Hi Lesley,
Thanks for the updated report.
Most issues are now resolved and this is appreciated.
The findings of the trial pits are helpful.

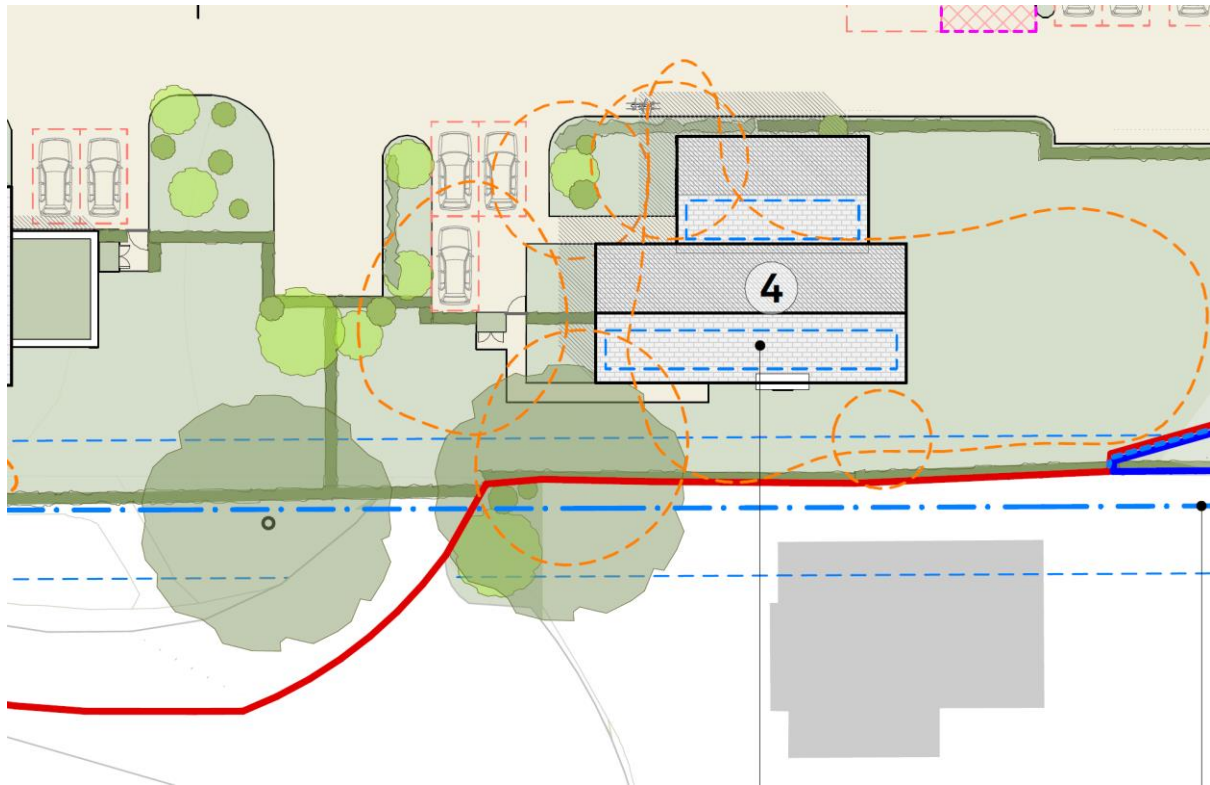
I would require that the tree protection measures are updated to reflect this change, and once approved, enforced fully throughout the development.

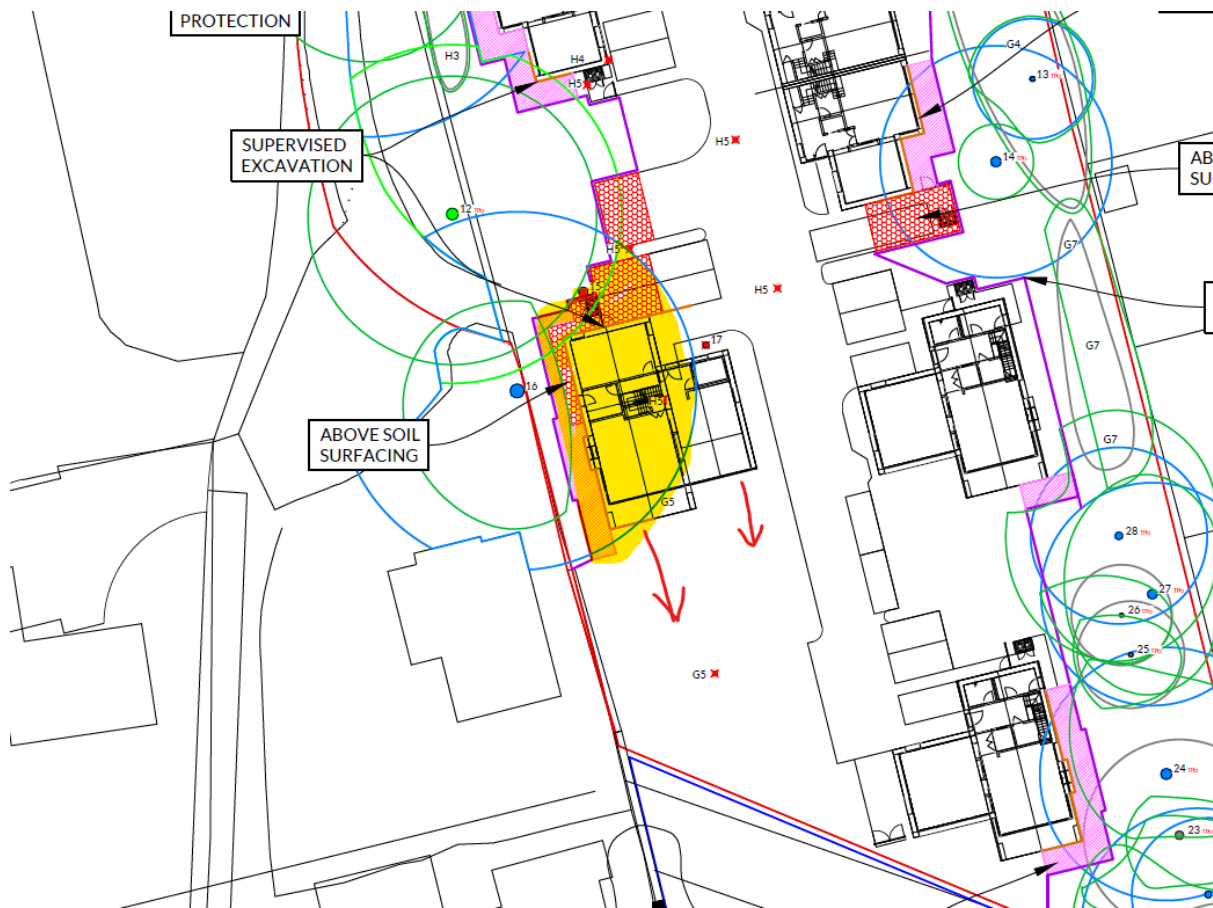
The total potential incursion is 27% (mis-stated on the schedule as 5.5% - I think an error as the two figures above seem correct).

This is both beyond the guidance in the British Standard 5827 and, given that the above ground construction will have SOME impact on the RPA, compounded by the impact of the construction of the dwelling which will not be limited to the actual footprint of the dwelling, this needs further consideration. This is apparently easily reduced/avoided if the southernmost property is moved to the south by several metres/rotated or the . There seems to be no reason to locate the proposed dwelling within the RPA:

If this is addressed to a satisfactory resolution then I can support the scheme on arboricultural grounds, but at it stands alternative arrangements must be considered to reduce this impact to retained T16.
